APPEAL SUMMARY

Appeal ID: 18965	Project Address: 7688 SW Capitol Hwy
Hearing Date: 2/6/19	Appellant Name: Matt Atkins
Case No.: B-018	Appellant Phone: 503-635-4425
Appeal Type: Building	Plans Examiner/Inspector: Steve Mortensen
Project Type: commercial	Stories: 2 Occupancy: A-3, B, E Construction Type: V-B
Building/Business Name: Multnomah Arts Center	Fire Sprinklers: Yes - Partial Standard 'Q', see enclosed Code Plan
Appeal Involves: Addition to an existing structure	LUR or Permit Application No.: Over-the-counter Review
Plan Submitted Option: pdf [File 1]	Proposed use: Unchanged

MULTNOMAH ARTS CENTER

Building Code Appeal #1

PERSPECTIVE VIEW OF AREA OF WORK

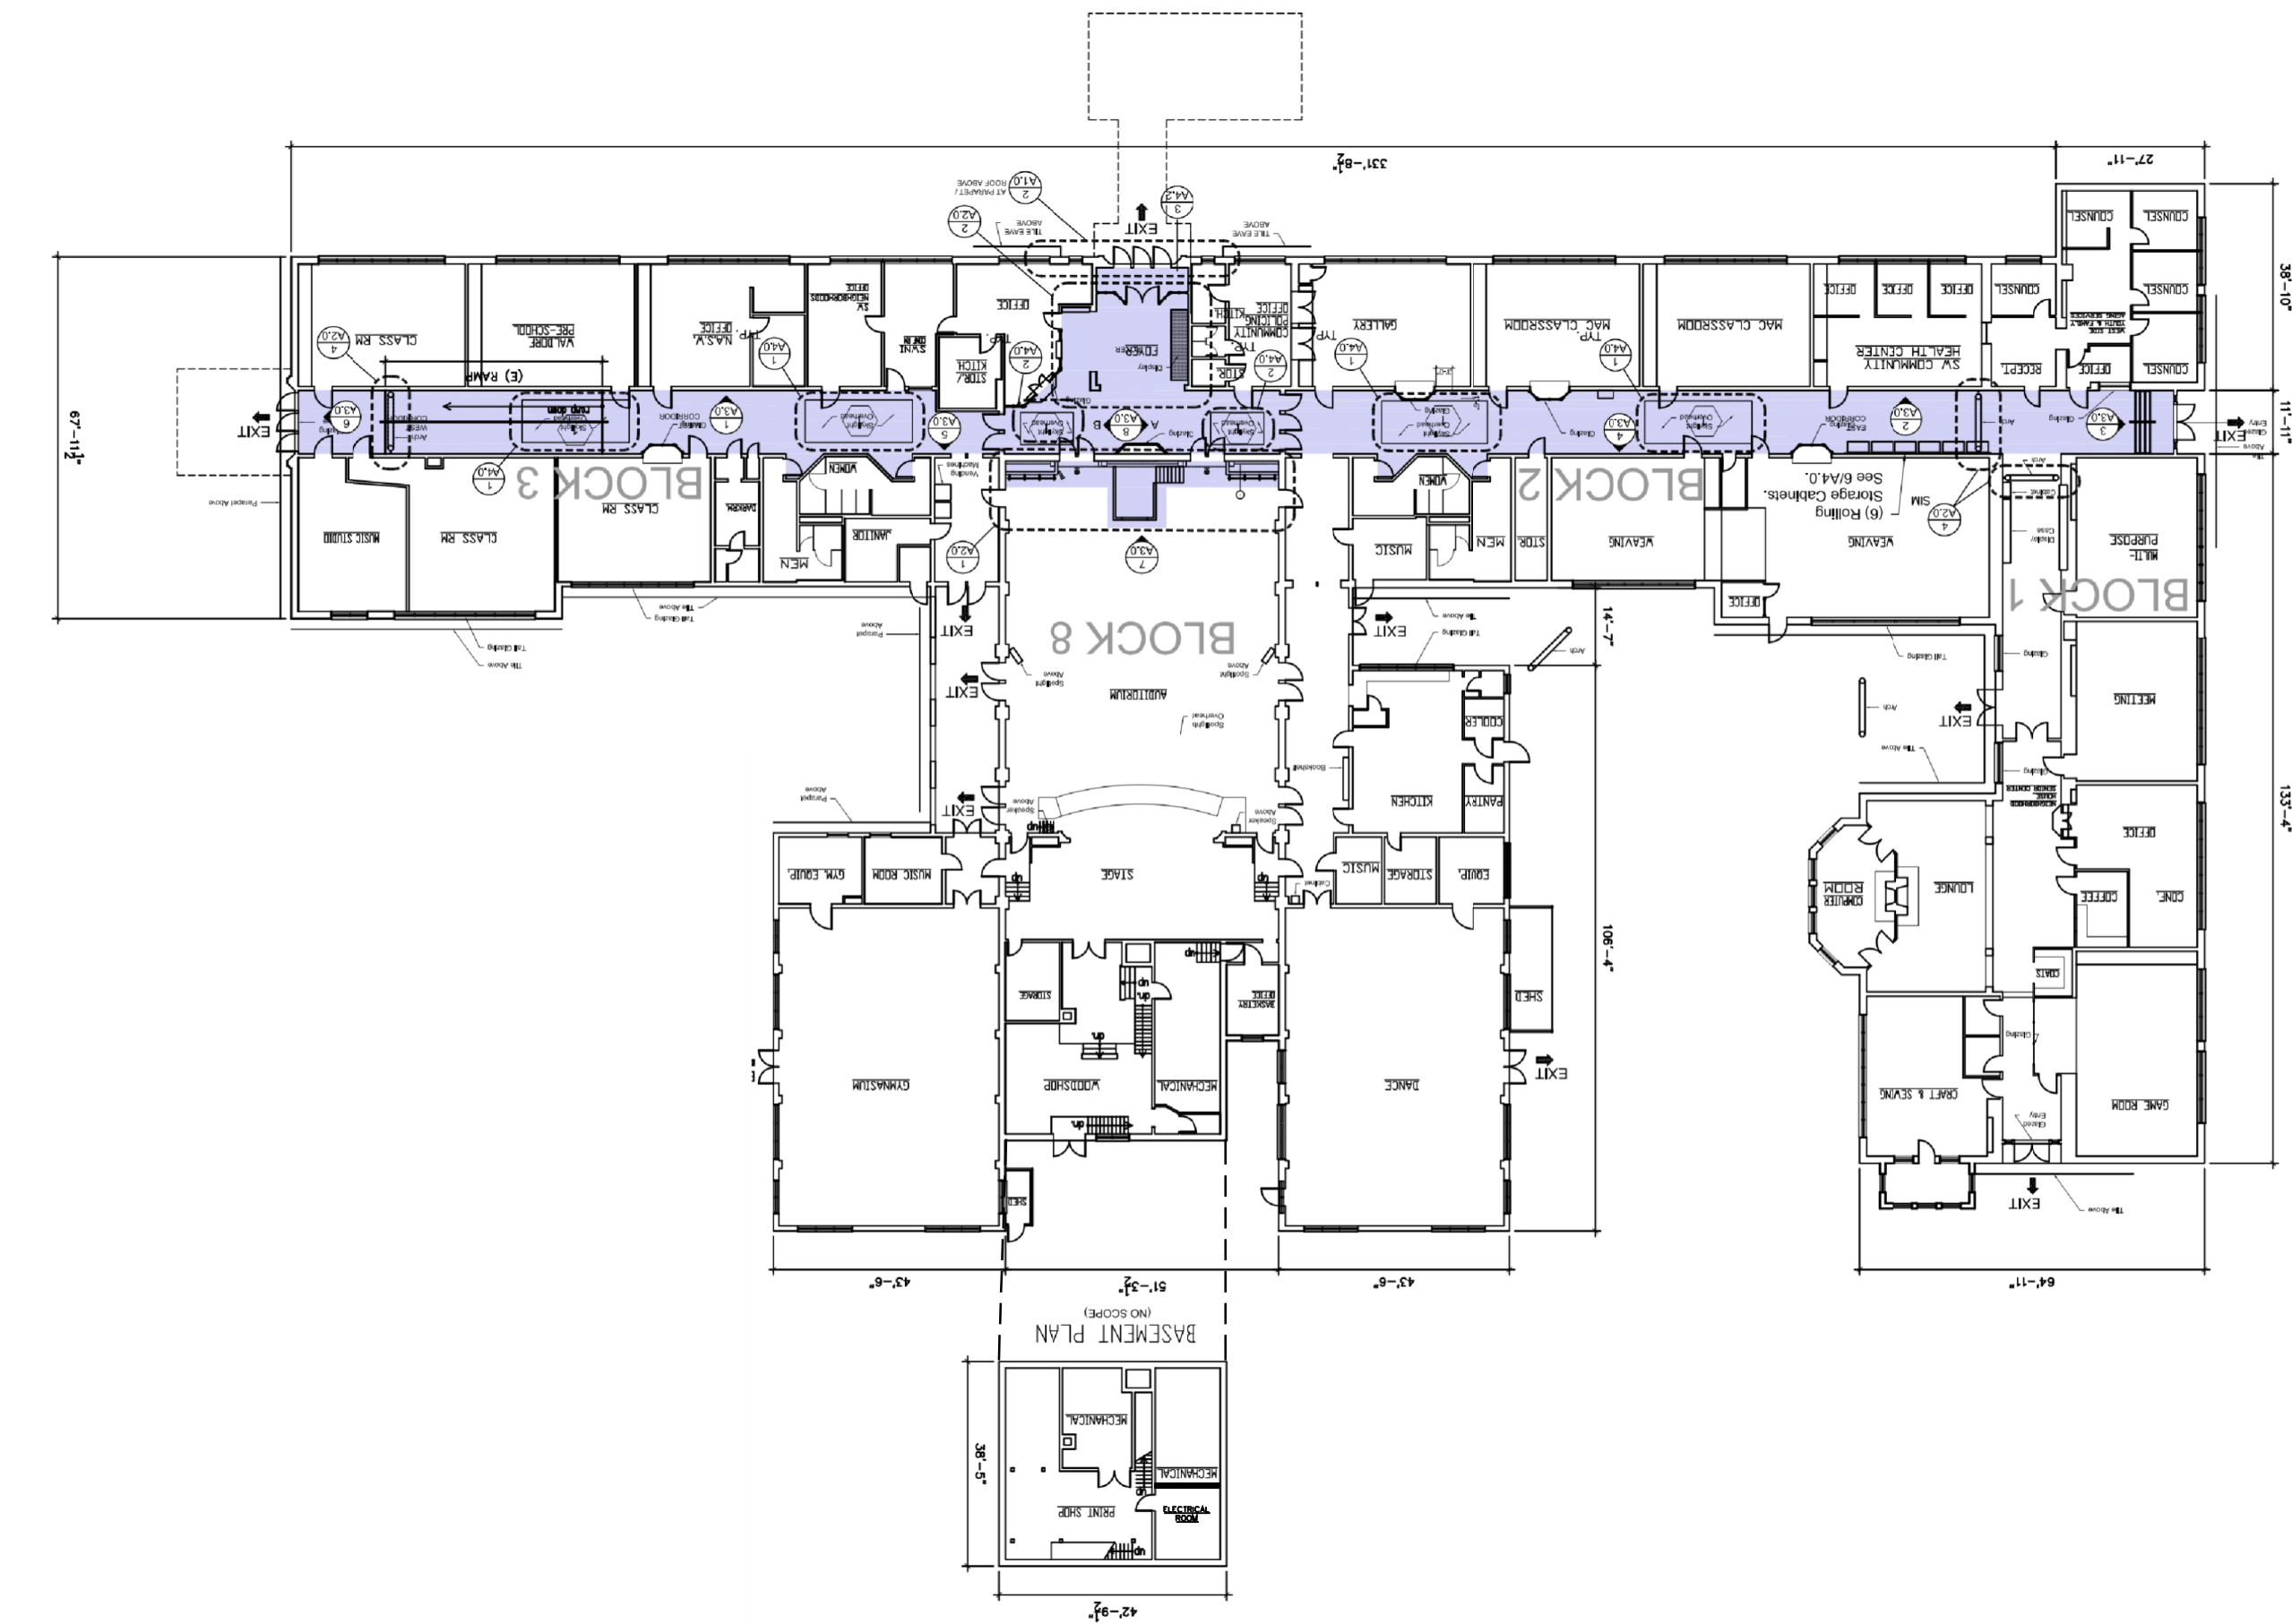
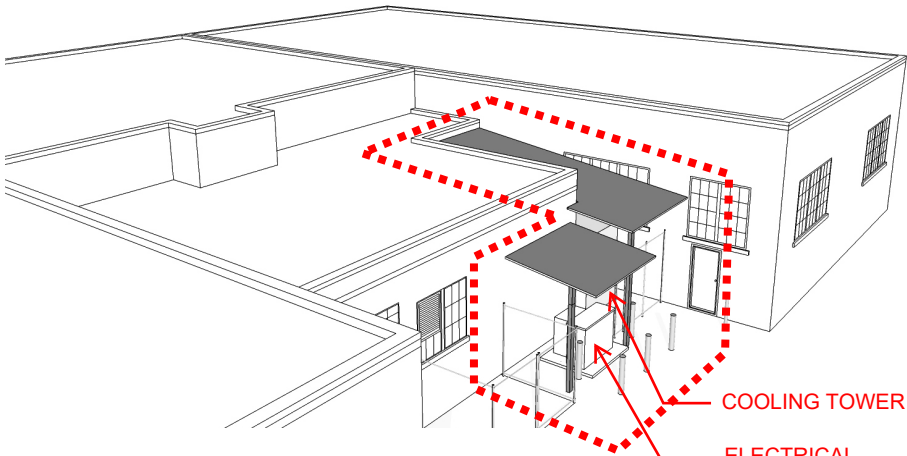
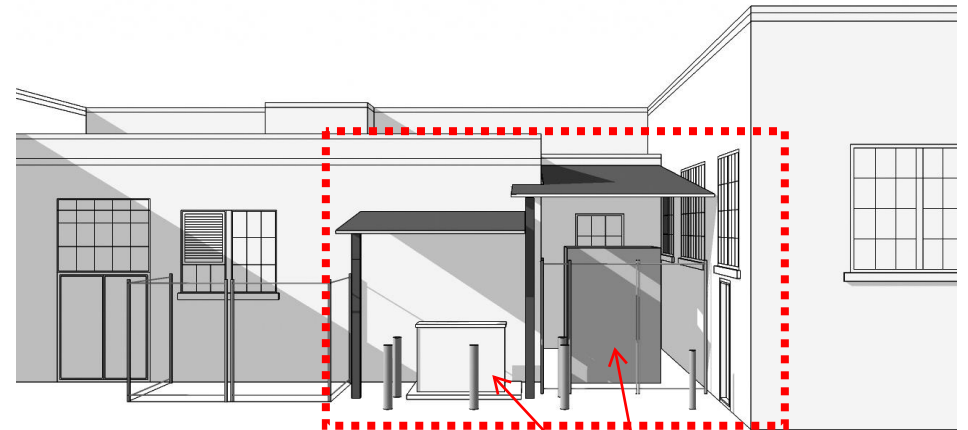
Reason for alternative Portland Parks and Recreation is proposing the roof addition to address an ongoing maintenance issue of water intrusion into the basement electrical room. The proposed roof will cover exterior mechanical and electrical equipment located in the vicinity of the basement foundation walls. The roof is designed to shed rain water away from the building's foundation. The mechanical space is typically non-occupied with the exception of periodic required maintenance on the equipment by maintenance personnel and or contractors.

The roof addition covers an area where exterior mechanical and electrical equipment are located. By UBC and 2014 OSSC code requirements, the added space is not considered occupiable space as defined in 2014 OSSC Chapter 2. The addition does not increase occupancy, change the current path of egress or hinder any accessible routes within the facility. Furthermore, the roof area is to be constructed with non-combustible construction.

Rain water intrusion into the basement electrical room presents a fire and life safety risk to the building. Other design solutions were explored, but all proved to be cost prohibitive by comparison. The proposed roof addition represents a small percentage increase of the total first floor area at 0.7% and will be constructed completely of non-combustible materials.

Equipment cover addition to building exceeding maximum allowable floor area: Granted as proposed.

CODE SUMMARY

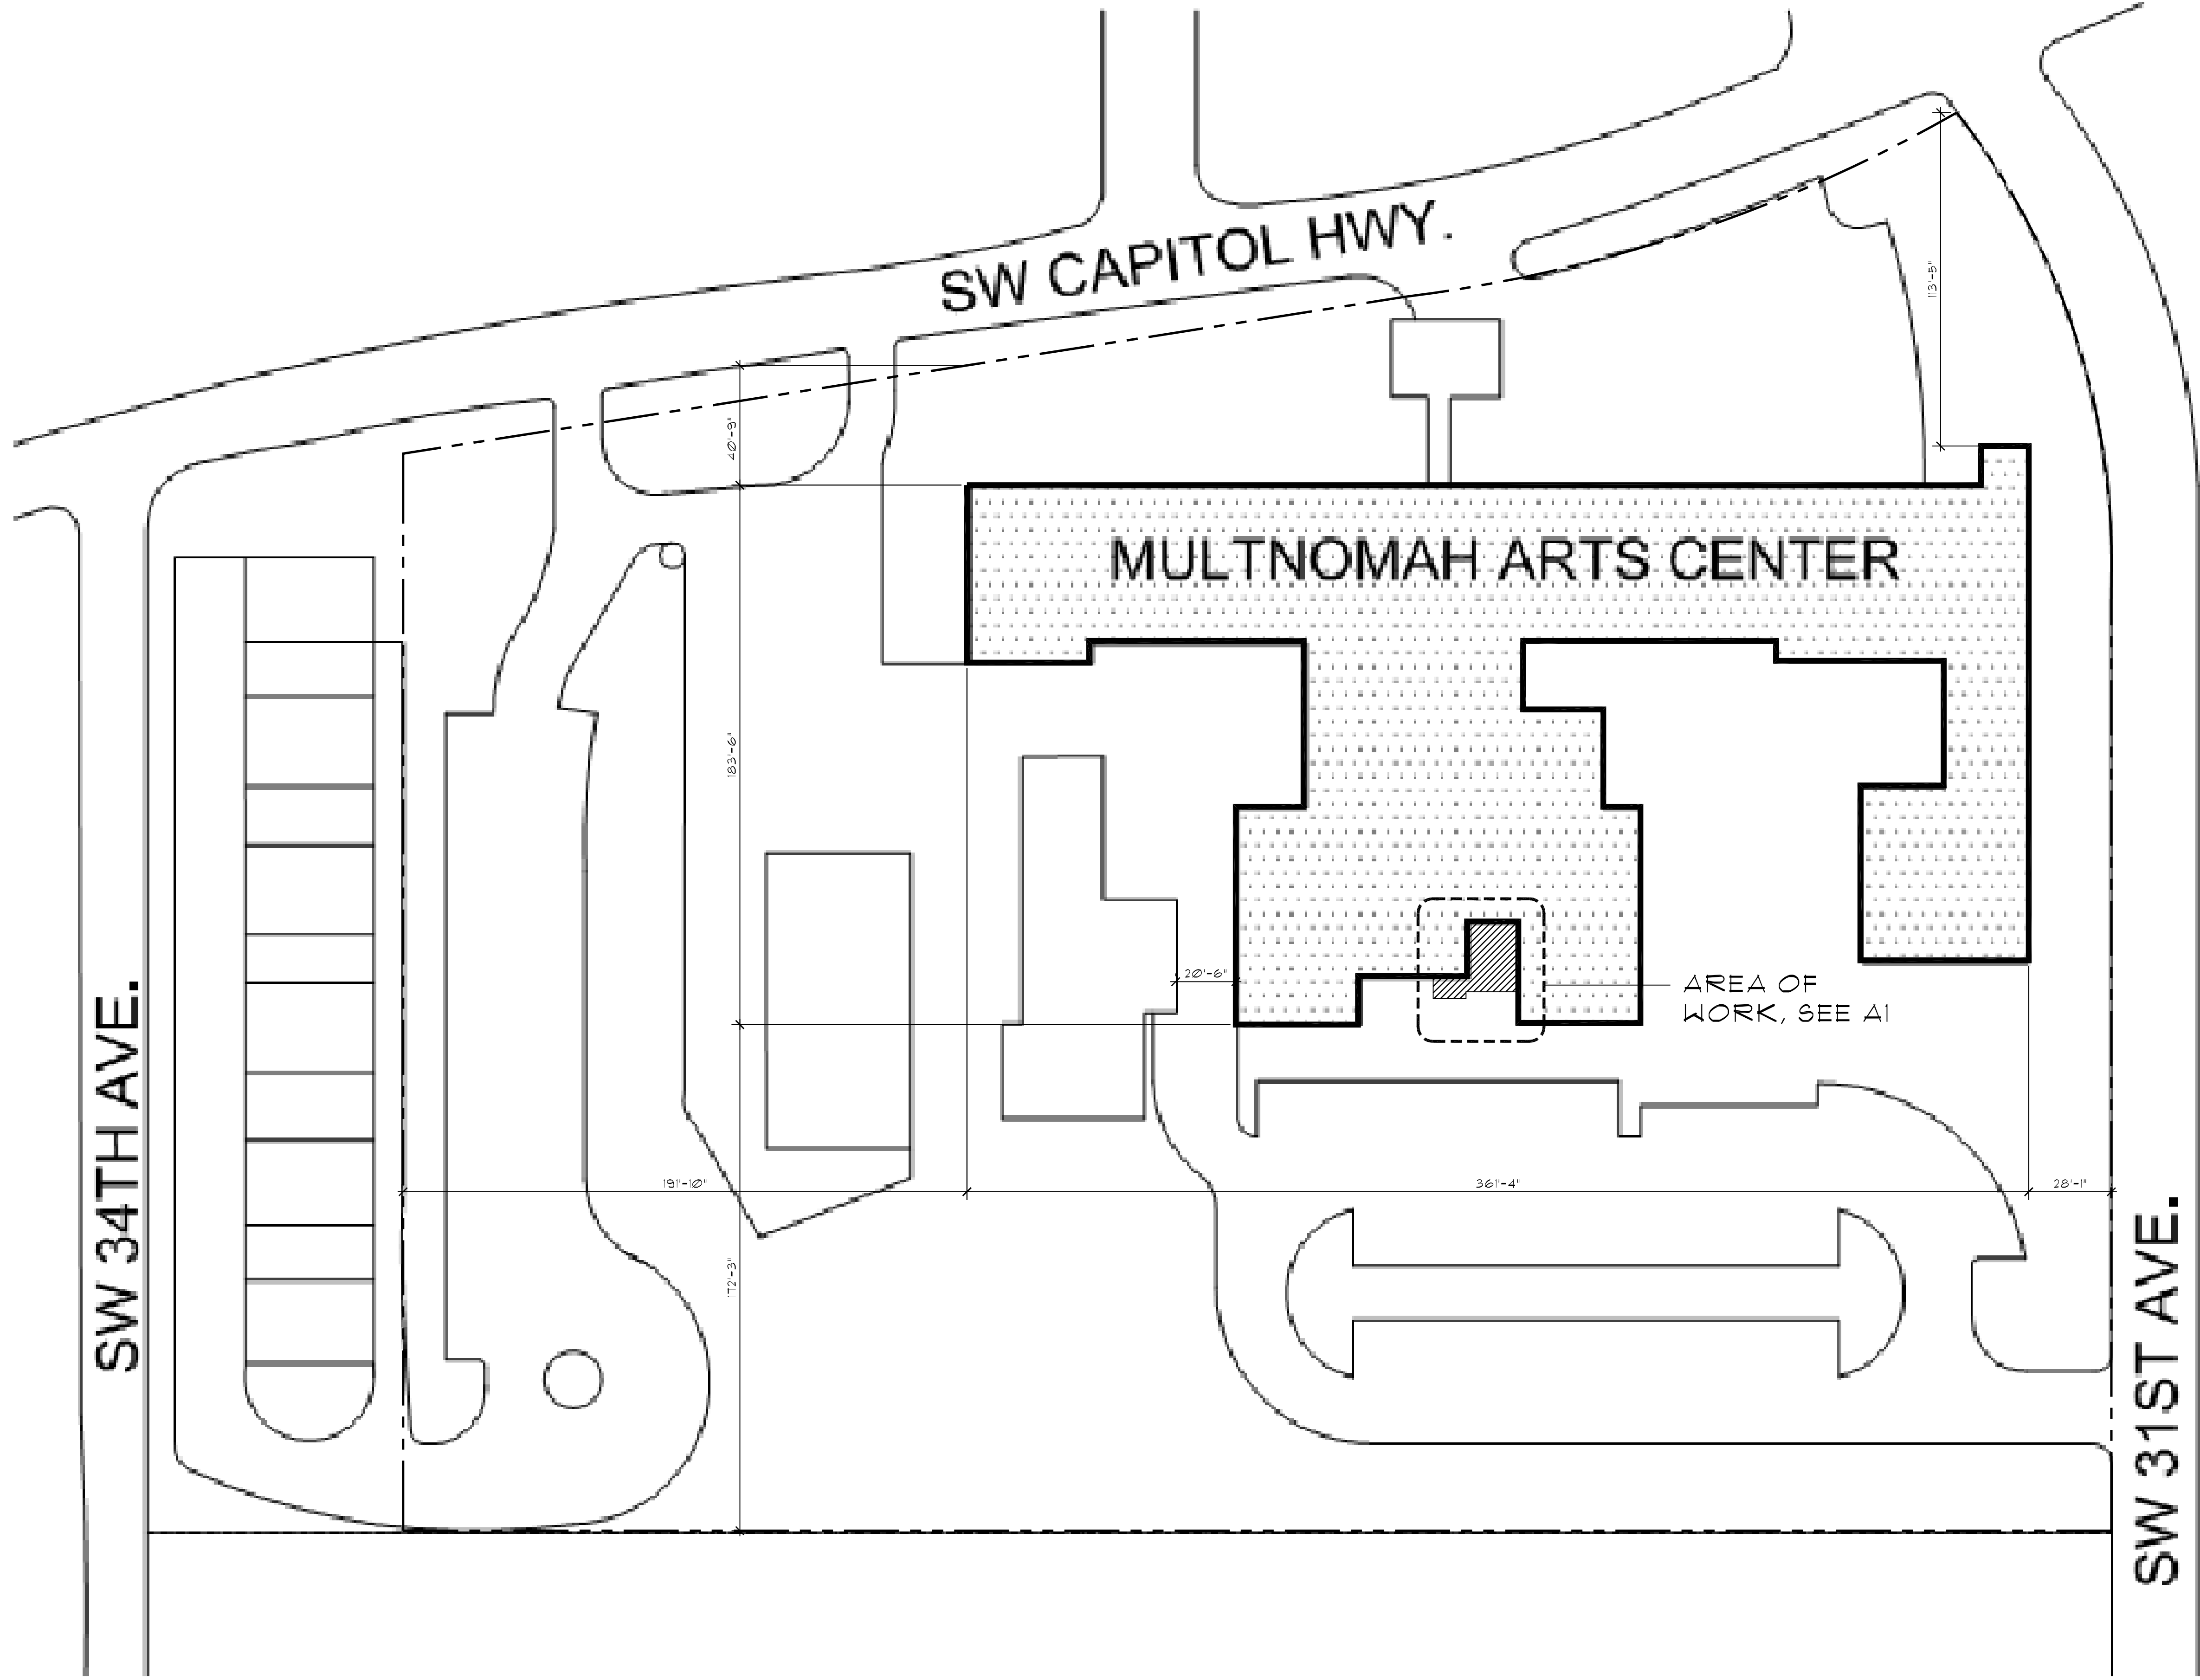
Proposed Design The Multnomah Arts Center is a City of Portland Parks and Recreation (PP&R) facility that was originally built in 1919 as an elementary school. The building underwent several major school renovations up through 1950's and then was renovated again in 1982 after it was acquired by (PP&R) in 1980. The building is classified as Type VB, and has been calculated as a mixed use non-separated occupancy, based on OSSC Table 503, to have an allowable floor area of 9,600 SF per floor. The existing facility is 48,931 SF on the first floor, roughly 500% over the allowable area. See enclosed Code Summary, Sheet G3.

Proposed Design: The Multnomah Arts Center is a City of Portland Parks and Recreation (PP&R) facility that was originally built in 1919 as an elementary school. The building underwent several major school renovations up through 1950's and then was renovated again in 1982 after it was acquired by (PP&R) in 1980. The building is classified as Type VB, and has been calculated as a mixed use non-separated occupancy, based on *OSSC Table 503*, to have an allowable floor area of 9,600 SF per floor. The existing facility is 48,931 SF on the first floor, roughly 500% over the allowable area. See enclosed Code Summary, Sheet G3.
